Pentium® II Processor Specification Update

Release Date: November 1998

Order Number: 243337-020

The Pentium® II processor may contain design defects or errors known as errata which may cause the product to deviate from published specifications. Current characterized errata are documented in this Specification Update.

Figure 1. UP Dual Ended Termination (DET)

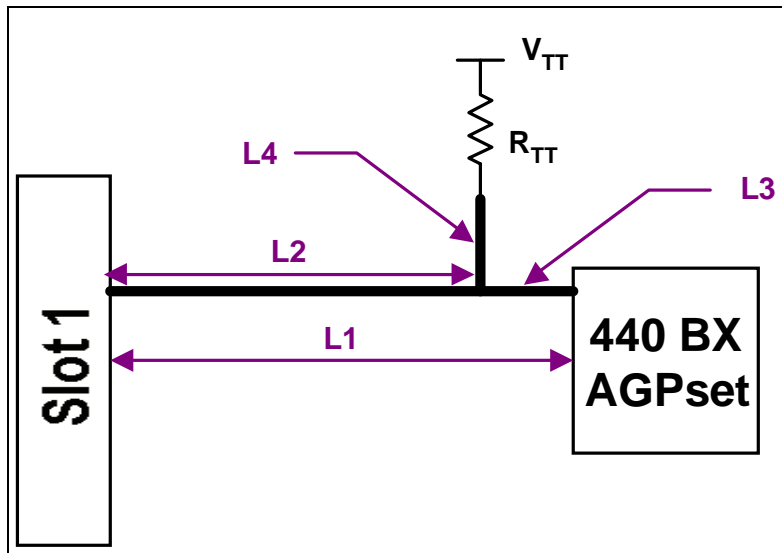
For UP-DET topologies (see Figure 1), the trace length $L1$ must be between 1.5" to 4.5" while using a 56Ω termination resistor.

Figure 2. DP Dual Ended Termination (DET)

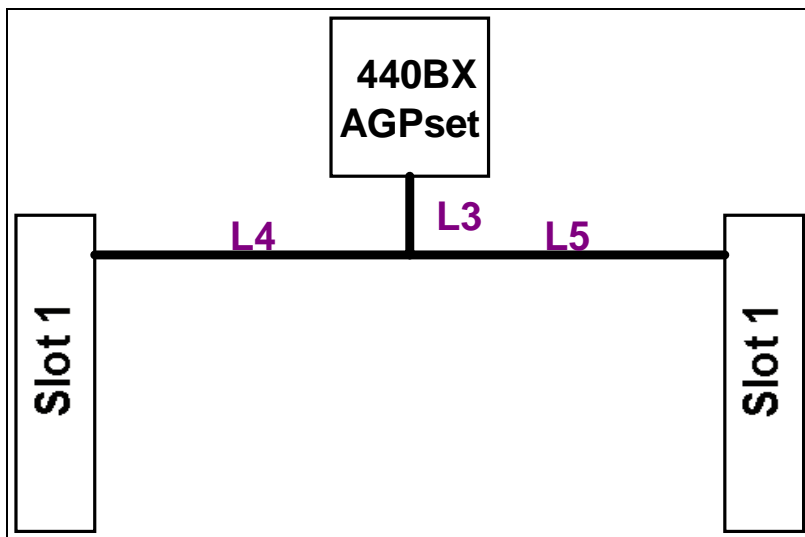
For DP topologies (see Figure 2) installed with a processor and a termination card, L4 + L3 or L5 + L3 must be less than or equal to 4.5". Additionally, for DP platforms with one processor installed, the termination card should be placed in the longer leg.

Figure 23. Processor with an Example Low Profile Heatsink Attached Using Spring Clips

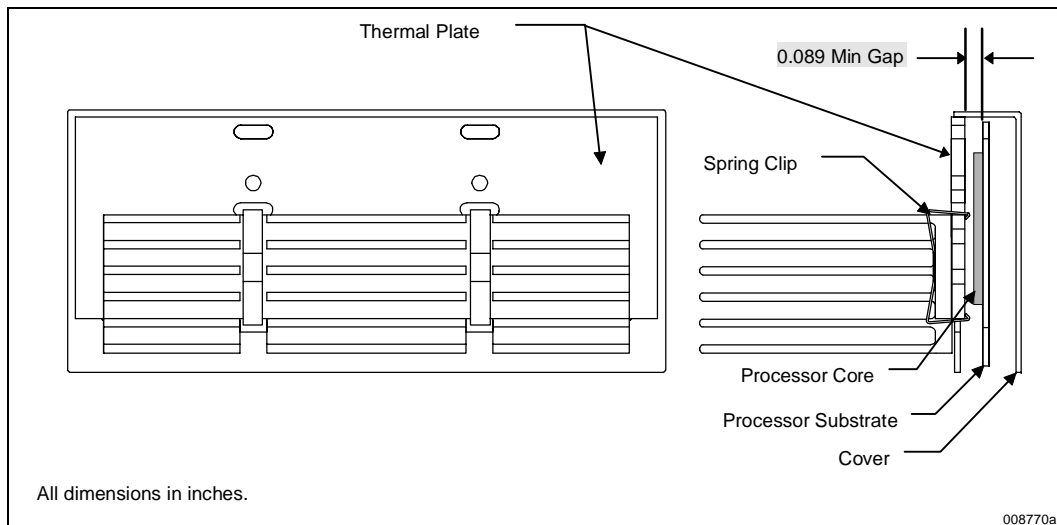
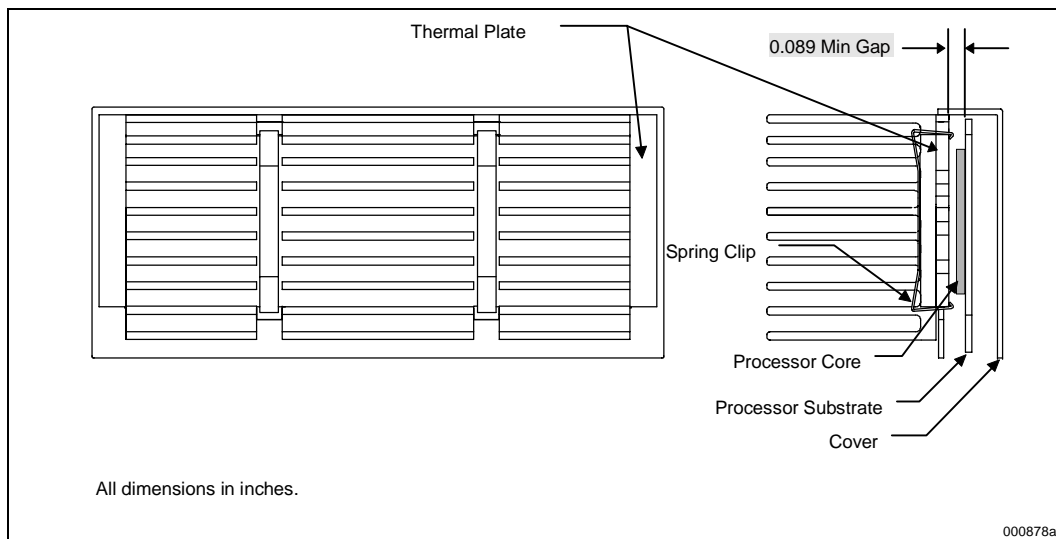
Figure 23 and Figure 24 illustrate example clip designs to support a low profile and a full height heatsink, respectively. The clips attach the heatsink by engaging with the underside of the thermal plate. The clearance of the thermal plate to the internal processor substrate is a minimum **0.089"** (illustrated in Figure 23 and Figure 24). The clips should be designed such that they will engage within this space, and also not damage the substrate upon insertion or removal. Finally, the clips should be able to retain the heatsink onto the thermal plate through a system level mechanical shock and vibration test. The clips should also apply a high enough force to spread the interface material for the spot size selected.

Figure 6. BCLK to Core Logic Offset

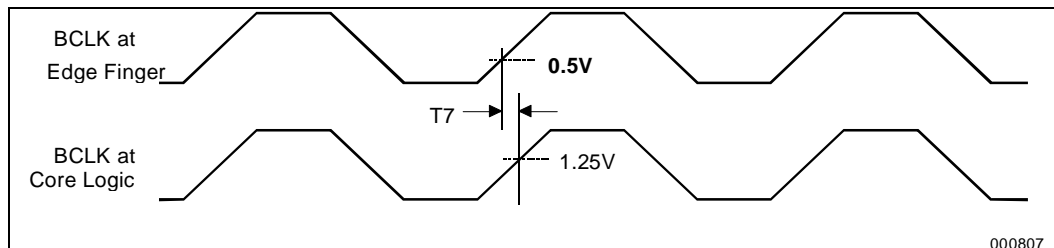
In Figure 6 of the *Pentium® II Processor at 233 MHz, 266 MHz, 300 MHz, and 333 MHz* datasheet, the following changes should be made:

Figure 7. BCLK*, PICCLK, and TCK Generic Clock Waveform

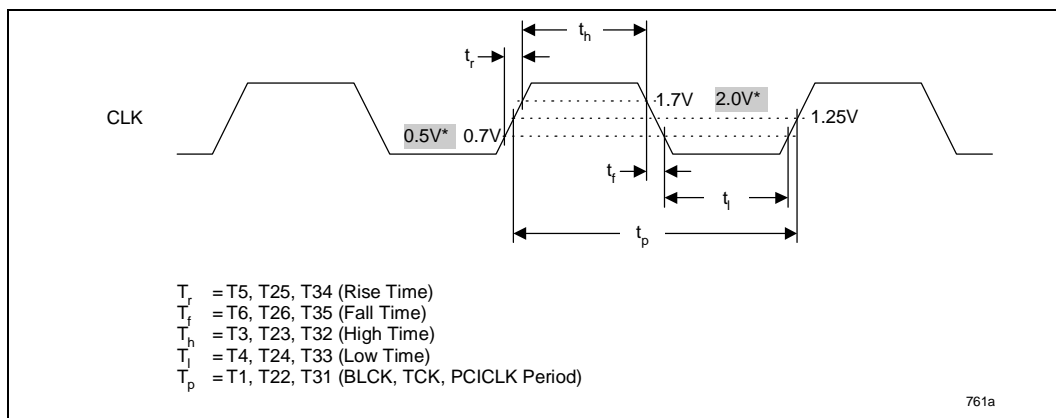
In Figure 7 of the *Pentium® II Processor at 233 MHz, 266 MHz, 300 MHz, and 333 MHz* datasheet, the following changes should be made:
